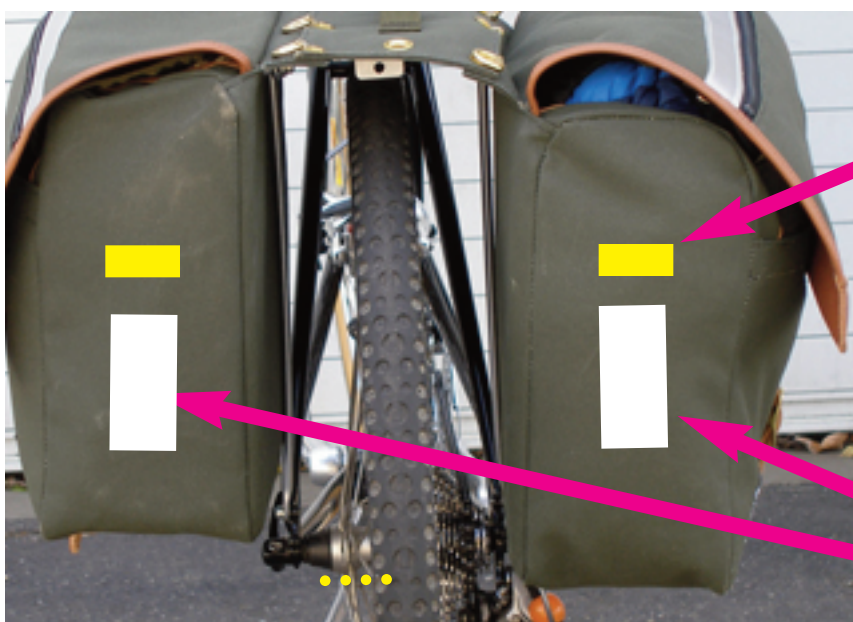
reshape this for better coverage, and it's OK to lose the contour with the front edge.

lengthen strap 2-inches so it'll reach with a too-big load, still.

these balls are groovy, likem a lot, couldn't fine orange. But it just occurred to me that you got orange because you got them at Home Depot. We may do that too, for the orangeness, but we're going to get 9-10 inchers, and both Dave and I have ordered them already, but in black. I like the orange, but we'll see how it goes. Some wouldabeen customers may squawk at the plastic balls, but the grommet there will let them use something more traditional..like Zip-Ties! Or whatever. Anyway, the balls work great.

put one of these in the bottom of each pouch as a drain hole. smaller is OK, doesn't matter...and reinforce as necessary or IF necessary so it doesn't rimp at the edges. I think this fabric can support a grommet, but be quadruple sure. thanks.

is it paranoia based on bad brains or a good idea to make this whole underside one piece of fabric? I don't mind the cost-due-to-waste; I just want it never to fail at a seam in 25 years or so. You know how these bags are stitched and riveted, so it's your call...but all things equal, one-piece seems groovier. We don't have a quote yet anyway, but I can handle a bit of an upcharge... Think about that and if I'm being too weird and just don't know, then stick with this.

rivet or stitch on a 3/4-in tall x 2-in wide leather or web strap for a red blinky light.

This may be a "one side only" deal too, or I may cave in to the resident symmetrists and England-Japan sympathizers and go both.

position as you see, visually. exact distance above botton no matter, but about like this.

i've got some 2--inch 3M coming, otherwise same as the other. At the last minute I may request none on this right-side pannier, and either a big one or two on the left. I'm fine with the asymmetry, and it makes sense.
